Access Compliance Report

Public Rights-of-Way

(Curb Ramps)

Intersection ID: 28485	Main Street: REA_RD	Cross Street: WINDSOR_RIDGE_DR	Location: NW
ADA ID: EDE1544B878F	Ramp Type: BlendTrans2	Initial Pass/Fail: Fail	Overall Compliance: No
			Severity Score: 21.25

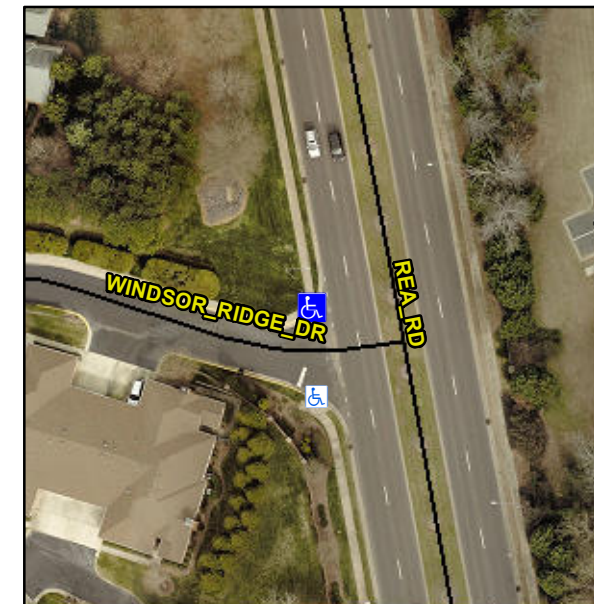
Not Found, R304.5.1, R304.5.3

Compliance	Description	Data	Compliance	Description	Data
N/A	Ramp Length (in)	47.0	Yes	BlendTrans Slope (%)	4.1
No	Ramp Width (in)	43.0	No	BlendTrans XSlope (%)	6.1
N/A	Flare Type LT	N/A	N/A	Flare Type RT	N/A
N/A	Flare Slope LT (%)	N/A	N/A	Flare Slope RT (%)	N/A
N/A	Flare Traversable LT?	N/A	N/A	Flare Traversable RT?	N/A
N/A	Landing Length (in)	N/A	N/A	DWS Provided?	N/A
N/A	Landing Width (in)	N/A	N/A	DWS Contrast?	N/A
N/A	Landing Slope (%)	N/A	N/A	DWS Length (in)	N/A
N/A	Landing X Slope (%)	N/A	N/A	DWS Full Width?	N/A
N/A	Landing Curb? (Y/N)	N/A	N/A	DWS Offset (in)	N/A
N/A	Shared Landing?	N/A			
N/A	Gutter Ponding?	N/A	N/A	Gutter Slope (%)	N/A
N/A	Gutter Lip Ht (in)	N/A	N/A	Gutter X Slope (%)	N/A
N/A	Painted X Walk1?	No	N/A	Painted X Walk2?	N/A
	X Walk 1 Direction	To S		X Walk 2 Direction	N/A
	X Walk 1 Width (in)	N/A		X Walk 2 Width (in)	N/A
	X Walk 1 Slope (%)	0.7		X Walk 2 Slope (%)	N/A
	X Walk 1 X Slope (%)	3.5		X Walk 2 X Slope (%)	N/A

N/A	Ramp inside XWalk1?	N/A	N/A	Ramp inside XWalk2?	N/A
	Road Slope (%)	3.5		Clear Space?	N/A
	Road X Slope (%)	0.7	N/A	Clear Space to XWalk (in)	N/A
N/A	Any Obstructions?	N/A	N/A	Storm Grate/Utility Hazard?	N/A
	Obstruction Type			Storm Grate/Utility Type	
		N/A			N/A
			Yes	Surface Condition? (G/P)	Good
			No	Curb Slope (%)	18.0

Remove & Replace Curb Ramp With Two New Directional Ramps or Equivalent.
